ADDENDUM NUMBER ONE (1) TO THE PLANS AND SPECIFICATIONS FOR:

City of Port Aransas Public Safety Center Port Aransas, Texas Project No. 18.22

ADDENDUM

DATE: May 31, 2023

OVERALL ARCHITECTURAL SITE PLAN - ALT. #1

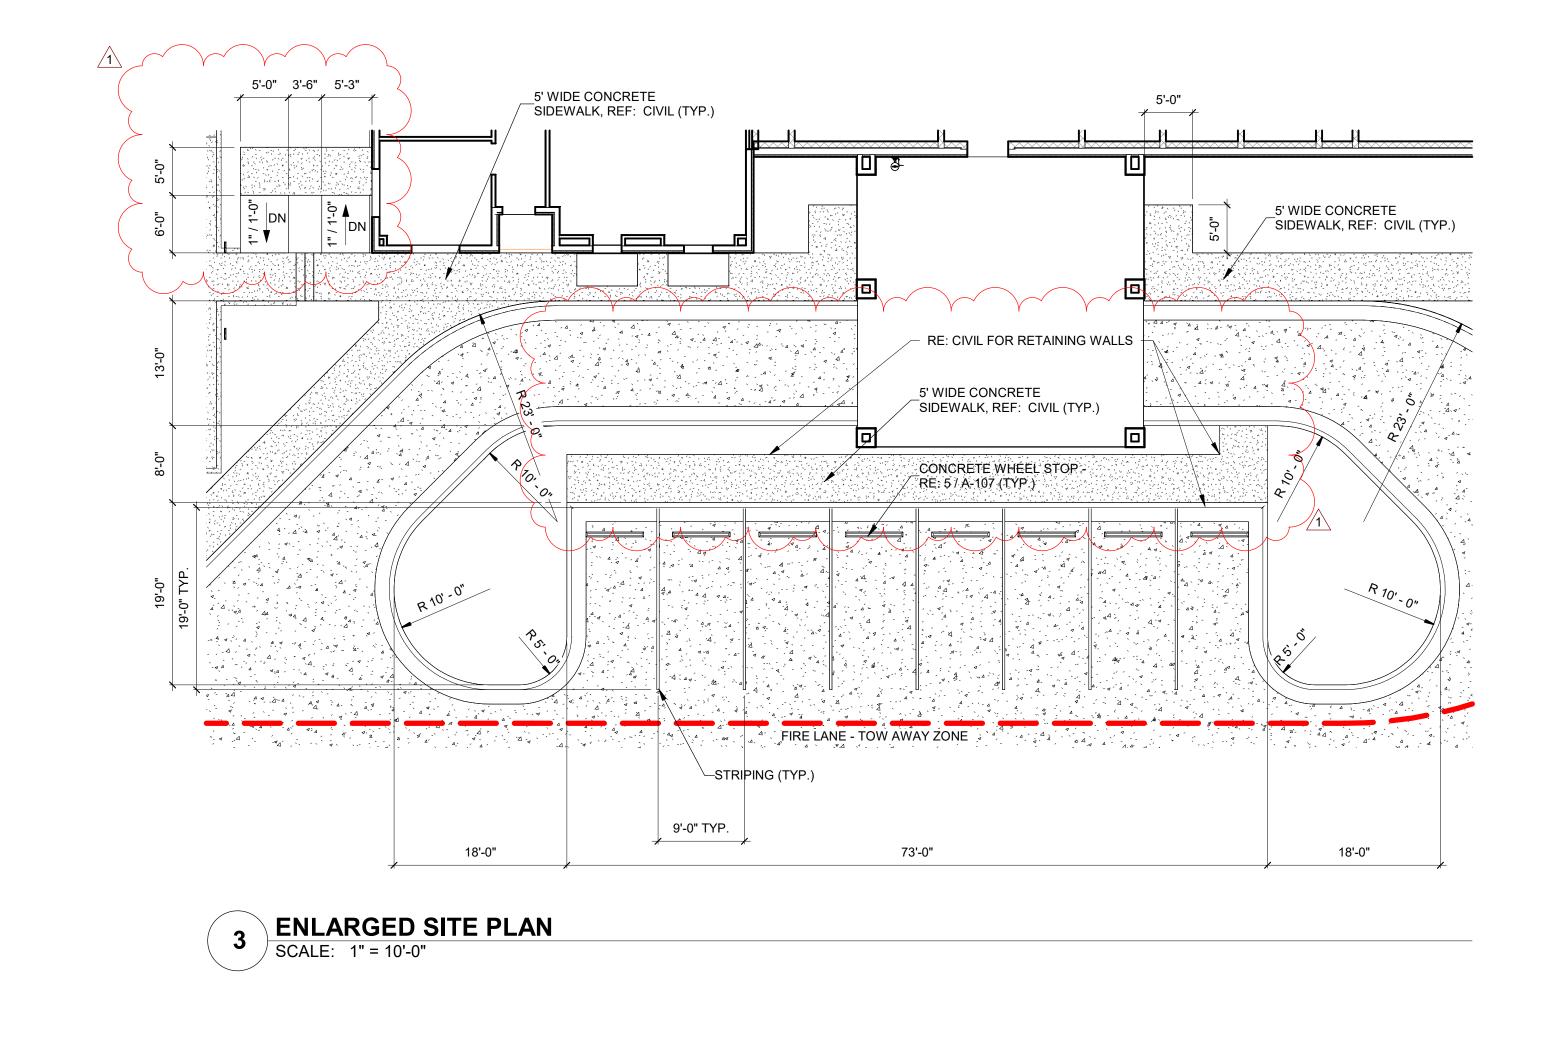
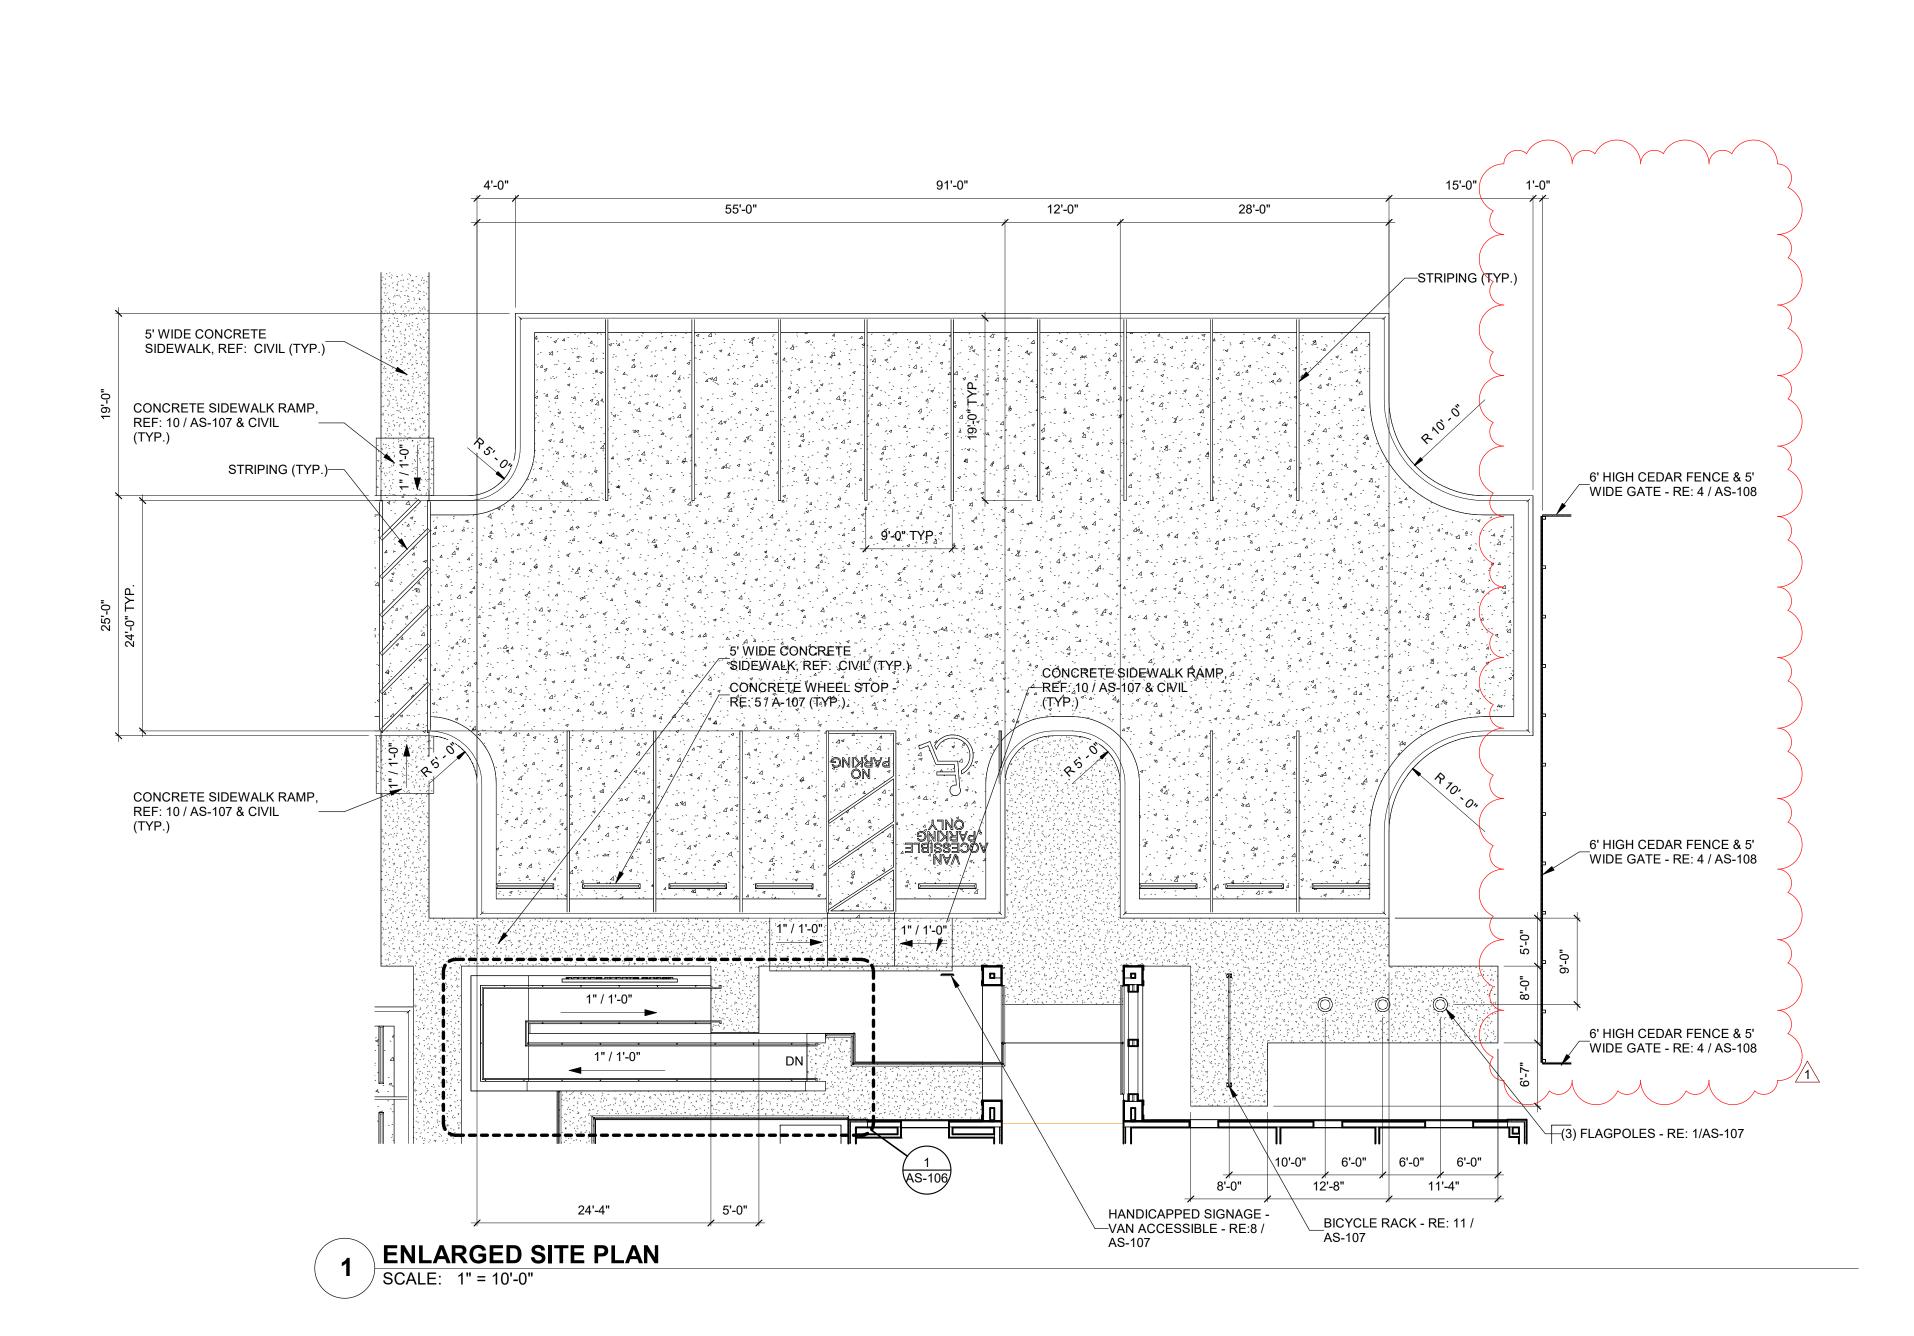
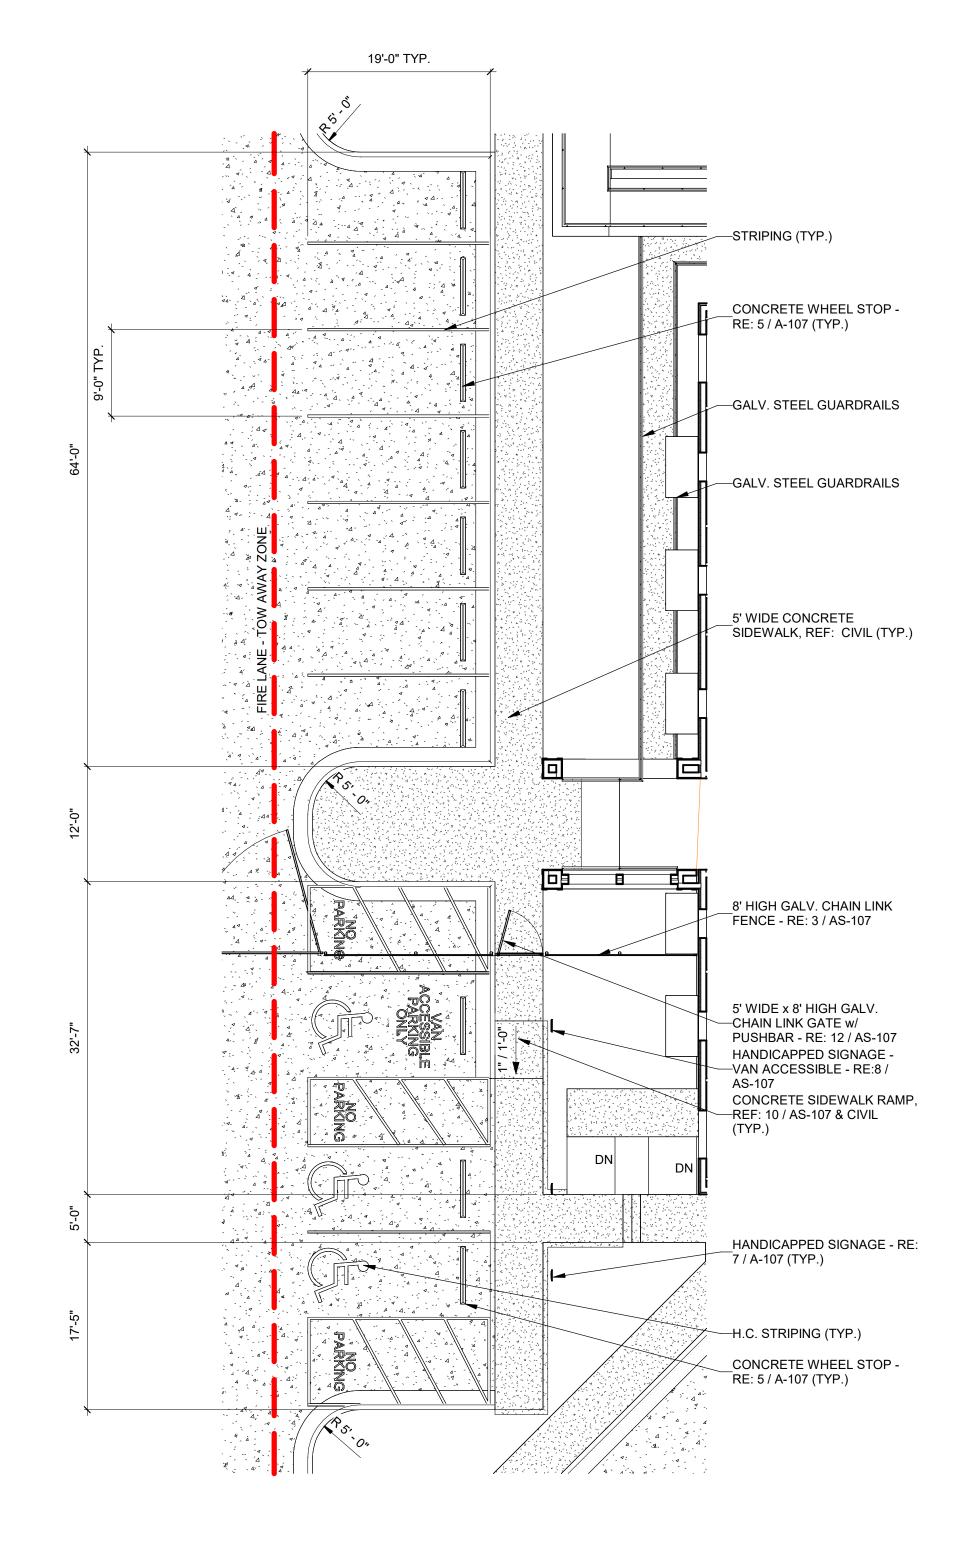
- 1. Delete this sheet in its entirety and replace with sheet AS-102, included within this addendum.
- 2. Added & designated shade structure as Alt. #1.

REFLECTED CEILING
PLAN

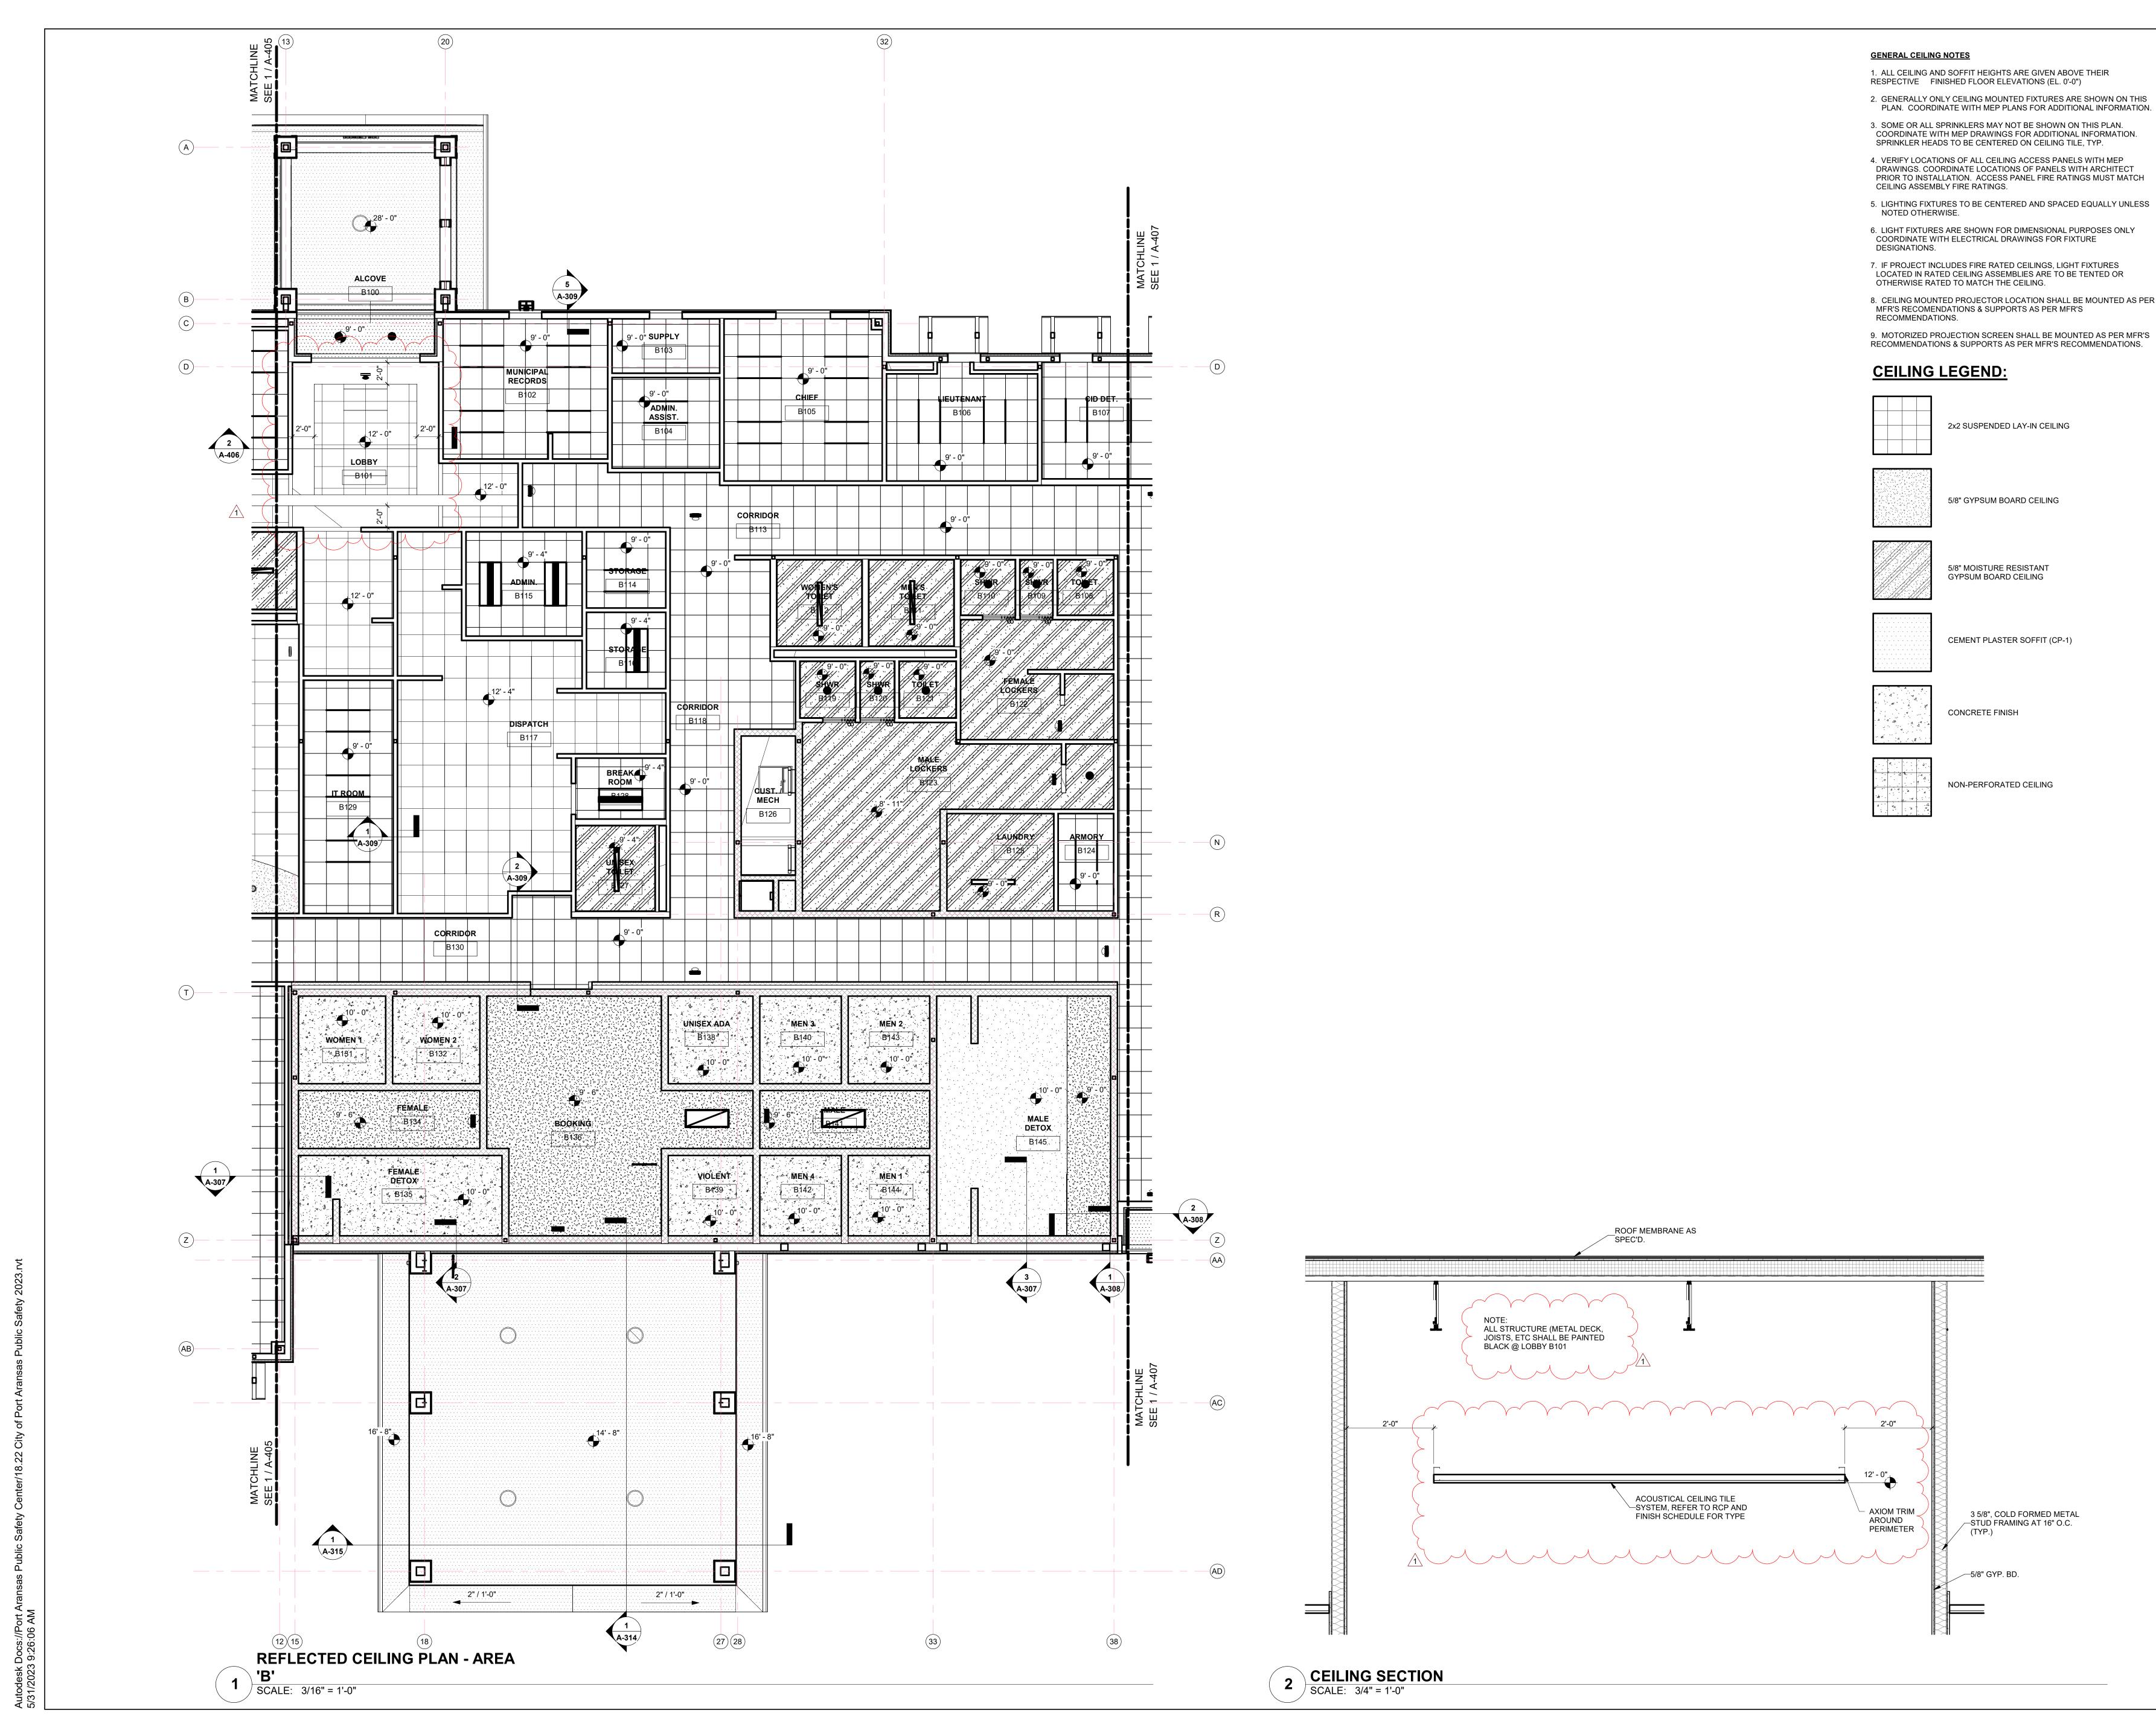
- 1. Delete this sheet in its entirety and replace with sheet A-404, included within this addendum.
- 2. Revised ceiling in Lobby B101.
